Preliminary Drainage Report

The Shire at Old Ranch

PPR2410

February 27, 2024

# Basin 87

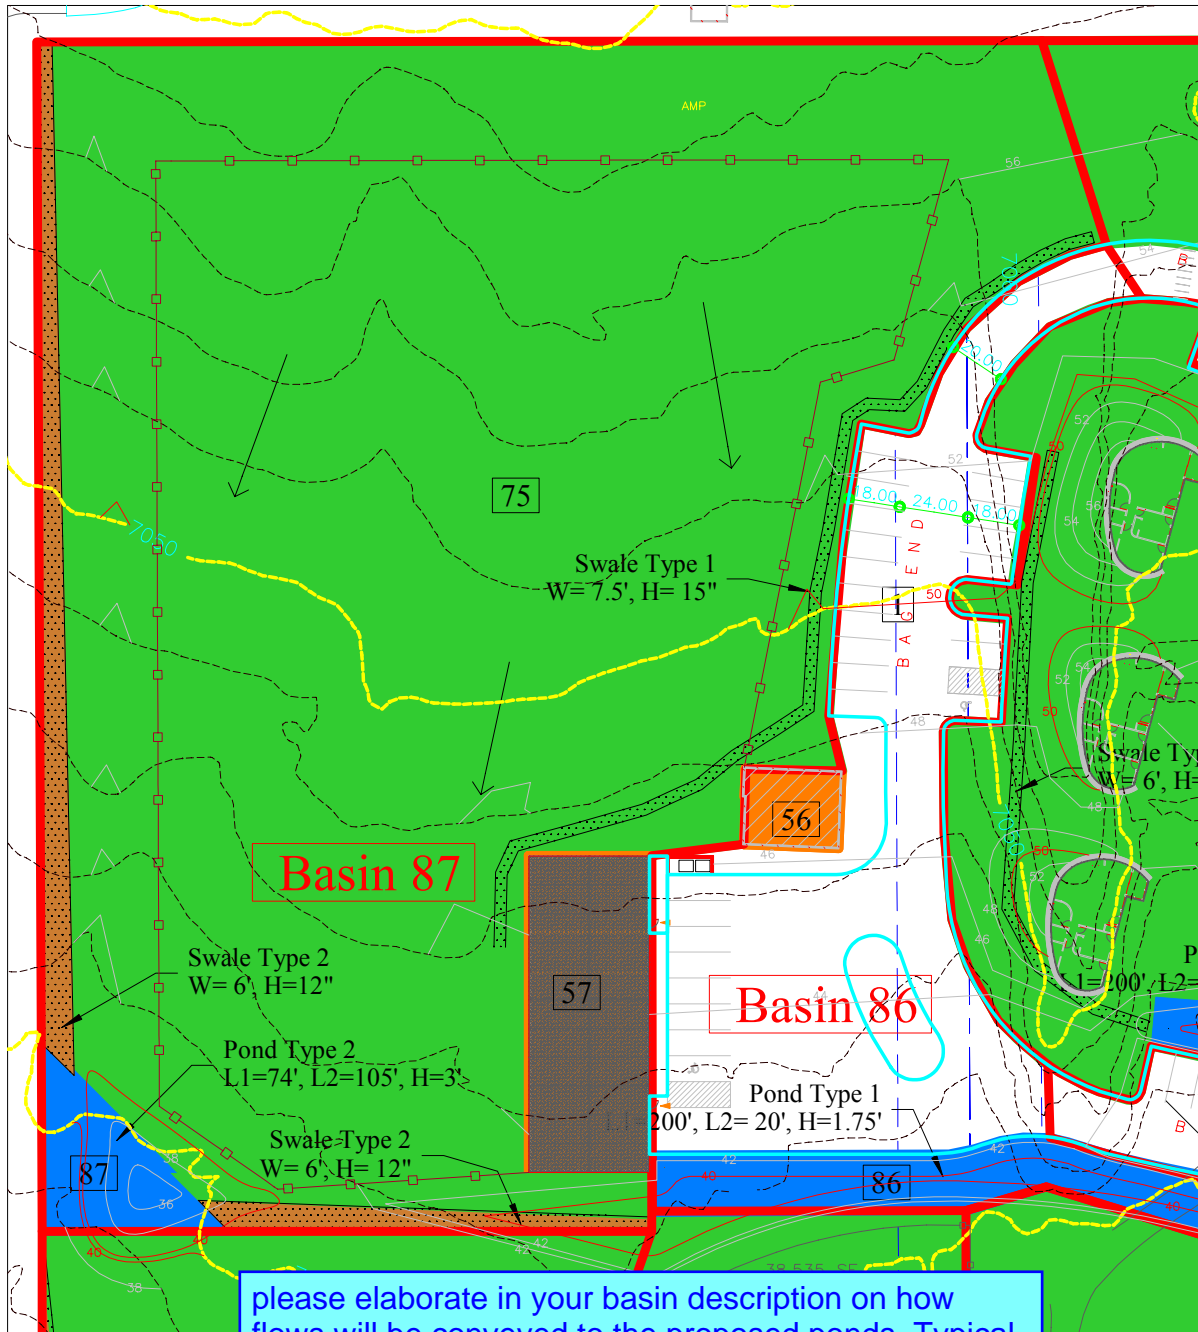
please elaborate in your basin description on how flows will be conveyed to the proposed ponds. Typical throughout the report

# Basin 87

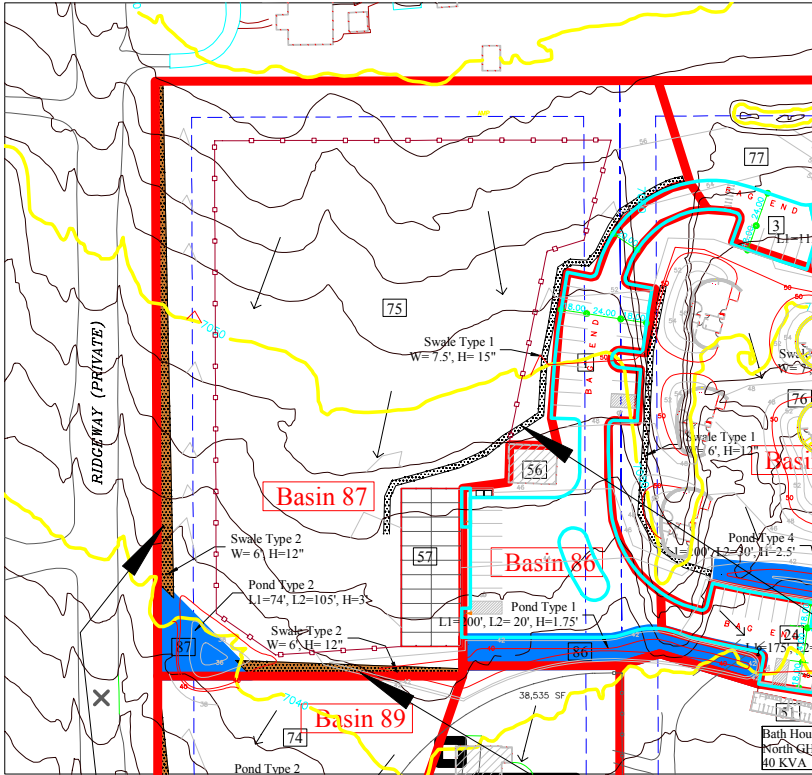
provide froude number and identify if the flow is sub or super critical for all the proposed channels. Identify any protection that is needed. Refer to DCMV1 Ch10. for permissible velocities.

# Basin 71

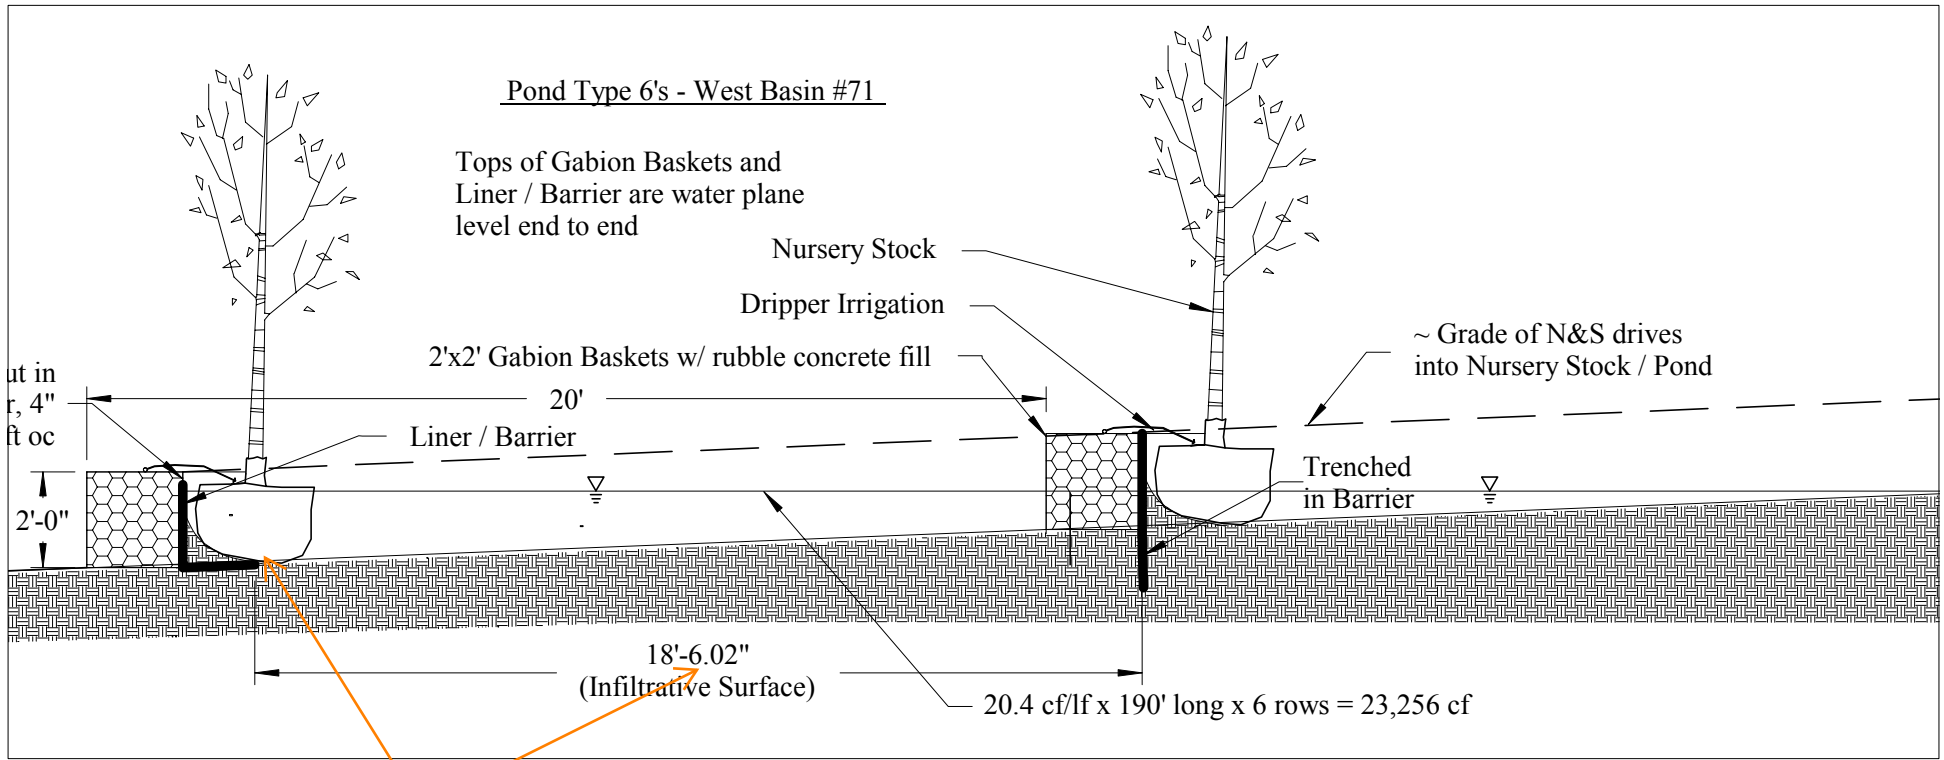
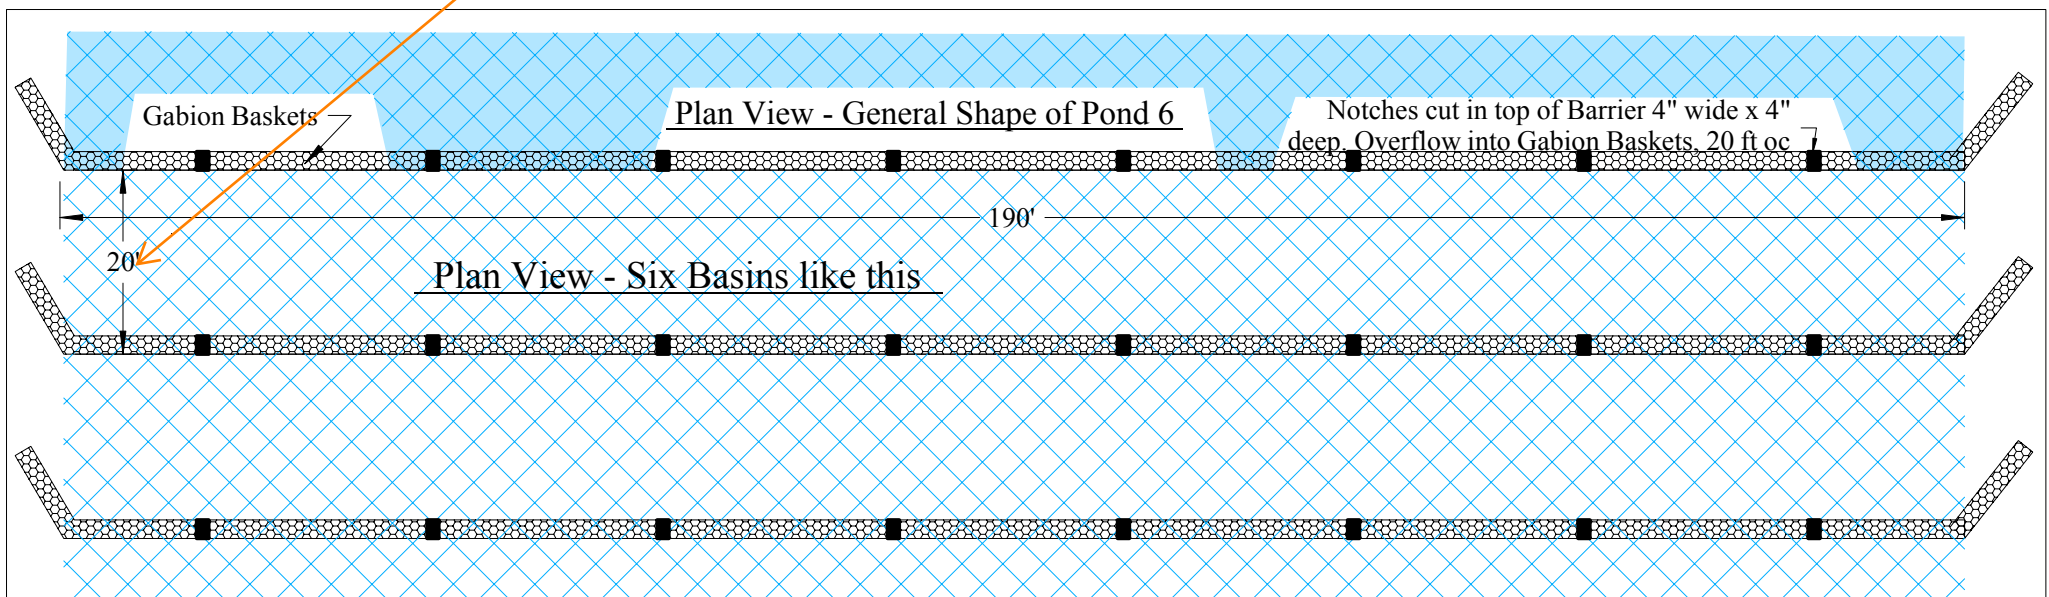
show trees in the plan view so it is clear the available infiltrative surface is not 20'
